# 88TH & NESBIT APARTMENTS

DESIGN REVIEW BOARD PACKET

9/8/2016

DPD # 3019553

MAIN ENTRY PERSPECTIVE

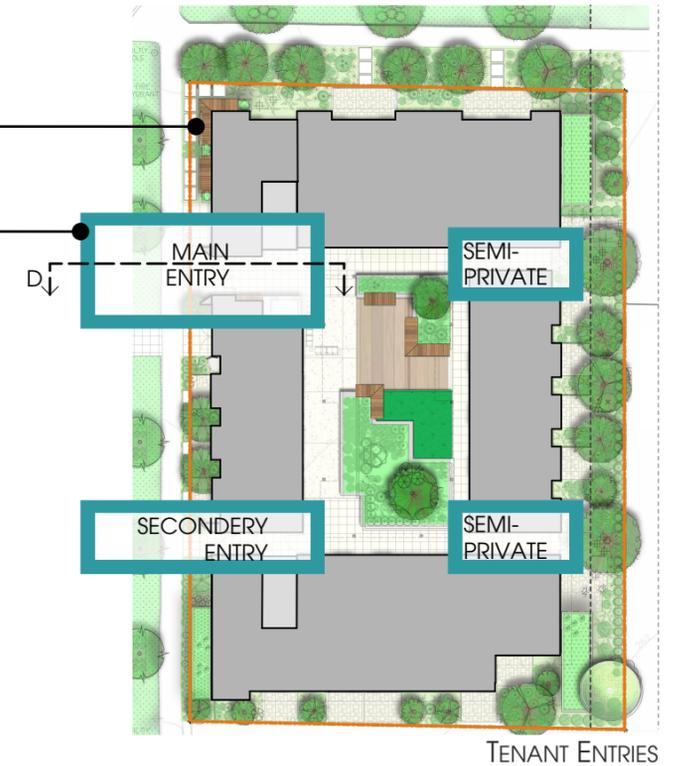
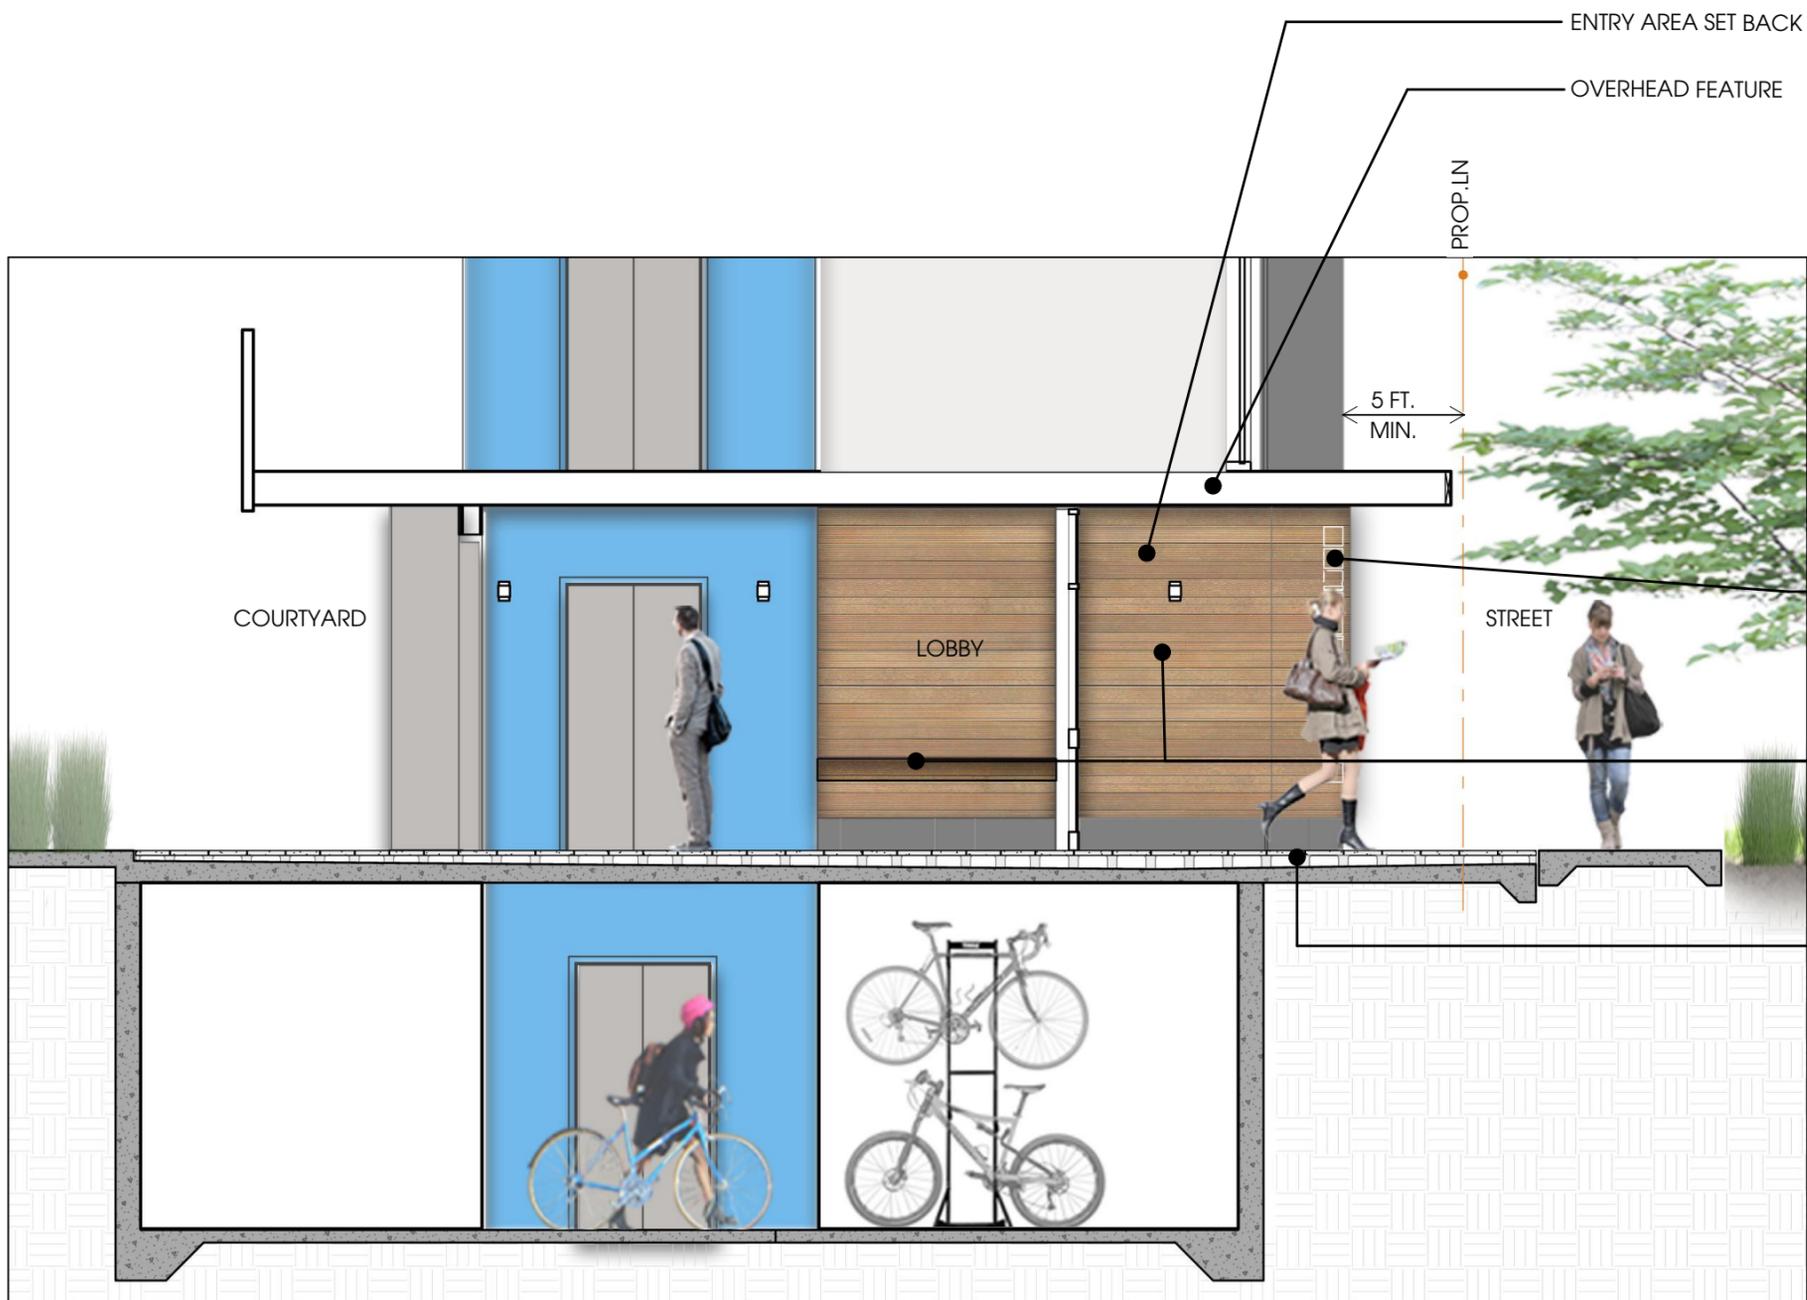
Early Design #1: (Item 3.a) The Board noted that the proposed design schemes have 4 entries but lack a hierarchy. Although the proposal does not include a residential lobby, a main entry to the site should be integrated into the design to give the project the experience of a front entry.

Land-use Corrections # 1: (Item 6) The multiple entries should have a clear hierarchy. In addition, the Board noted at EDG2 that "providing a strong connection to the street and public realm are a top priority (Item 1). Consider combining the office entry and residential entry and enlarge the paved area at the corner to create a more generous and welcoming entry.

1. Entry. The north entry should be clearly identifiable and welcoming. Consider combining the office and residential entry, and enhancing its presence with an awning, more welcoming features at grade such as paving or benches, landscaping, and signage.  
Applicant's Response: (Page 17,18)  
The north entry was revised to combine the office and residential entry and establishes opportunities to make a strong connection to the street and public realm. In the revised location, the primary entry connects all major points of access: the corner of the building, residents lobby, the courtyard area and the leasing office.

Applicant's Response: (Page 17, 18)

The north entry was revised to combine the office and residential entry and establishes opportunities to make a strong connection to the street and public realm. In that revised location, the primary entry connects all major points of access: the corner piece of the building, residents lobby, the courtyard area and the leasing office.

- (1) An enlarged paved area at the north-west corner was added to provide a significant common open space and encourages physical activity and social interaction. The design proposes streetscape that adds color, texture, and distinctive paving materials.

- (2) The design provides the primary entry privacy and security for residents but also welcoming and identifiable to visitors. The entry area set back from the street and including identifiable and distinctive elements with clear lines of sight and lobbies visually connected to the street.

- (3) The design provides the primary entry physical and visual prominence. Along the Nesbit facade, occurs a break in the building with distinct vertical element and variations in color and material. To achieve human scale into the building's entry we are including welcoming features at grade such as overhead features, storefront door, paving, benches, landscaping and signage.

PERSPECTIVE | UNITS ENTRIES NESBIT AVE N

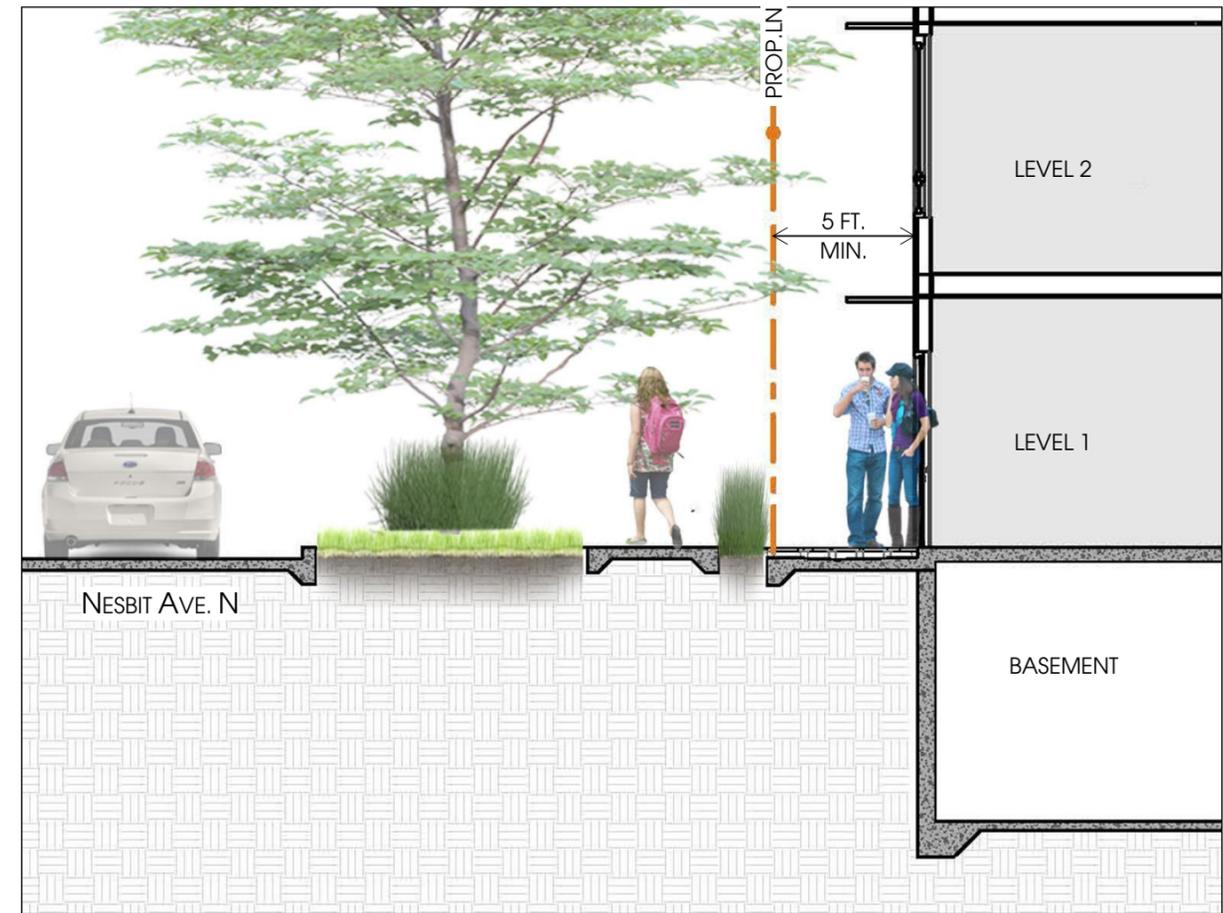
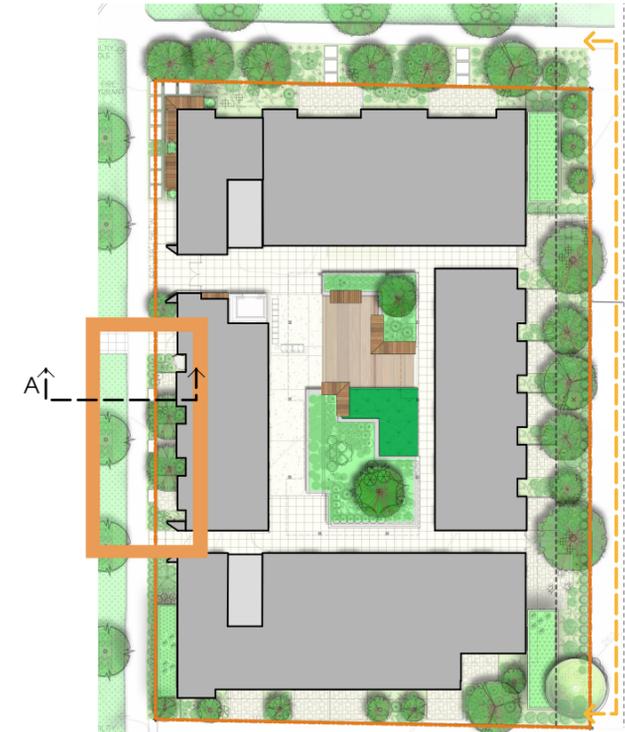
Land-use Corrections # 2: (Item 2) Architectural Concept & Relationship to the Street. At EDG, the Board noted that providing a strong relationship to the street and public realm was a top priority (item 1). Pay special attention to privacy and security of the ground-level units. Please provide details that demonstrate how these concerns were taken into consideration. This may include specific details regarding built-in window treatments, fencing materials, landscaping strategies, etc.

Let the Board know what your intention is with the small patio spaces on Nesbit--are they supposed to be accessible from the sidewalk, or have a buffer that prohibits direct access--and then demonstrate how your intent has been achieved.

Applicant's Response: (Page 19)

1. The ground floor units along Nesbit Ave N have direct access to the street. A stepping stone was added to access the unit from the sidewalk.
2. Through the use of a buffer we treat the small patio spaces on Nesbit as semi-private space. The streetscape character includes small planting area and patios along with other elements that work to create a transition between the public sidewalk and private entry.

CONTEXT RESPONSE, CORNER

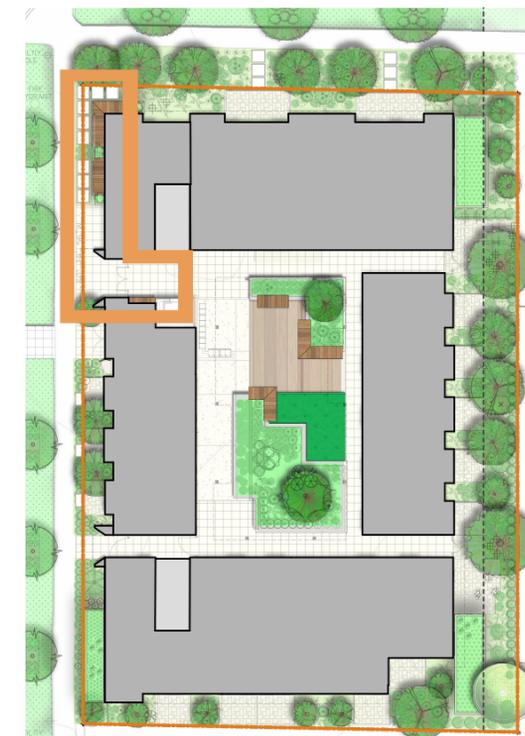
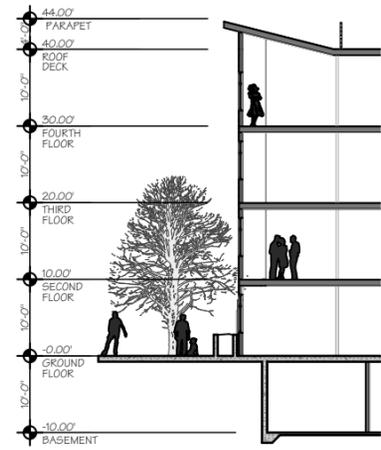
Early Design #1: (Item 1.a) The Board discussed the massing options at length; the majority of the Board present preferred the street-facing open courtyard in Option A as an appropriate response to the residential character of the context, and reduced the bulk of the massing. However, the Board agreed that further design exploration could result in a revised massing concept, and that the design should respond to the corner condition, modular unit construction, security concerns, and adjacent structures.

Land-use Corrections # 1: (Item 6) At EDG 1, the Board noted that the "design should respond to the corner condition, modular unit construction, security concerns, and adjacent structures (item 1.a). It does not appear that the massing or architectural composition respond to the corner location. Explore how the corner piece can be revised to create interest at the corner, both in the upper massing and at the ground floor. The corner massing could tie in to a more identifiable and welcoming entry, and respond to the Board's concern about creating a hierarchy of entries.

Applicant's Response: (Page 25)

The massing and architectural composition was revised to respond to the corner location. The following elements were considered in our revised design:

1. The upper and the ground floor units, are designed to be unique at the corner location. The corner now has an increased number of windows to promote daylighting, maximize transparency at the facade and develop an attractive and contemporary design. In addition, the windows create street views and resident interaction with the environment.

2. The roof at the corner locations was revised to a shed roof along with adding transom windows at the fourth floor.
3. The north entry was revised to combine the office and residential entry and establish physical and visual prominence at the building corner. The primary entry connects all major points of access: the corner of the building, residents lobby, the courtyard area and the leasing office. An enlarged paved area at the north-west corner was added to provide a significant common open space and encourage physical activity and social interaction. The design proposes streetscape that adds color, texture, and distinctive paving materials.
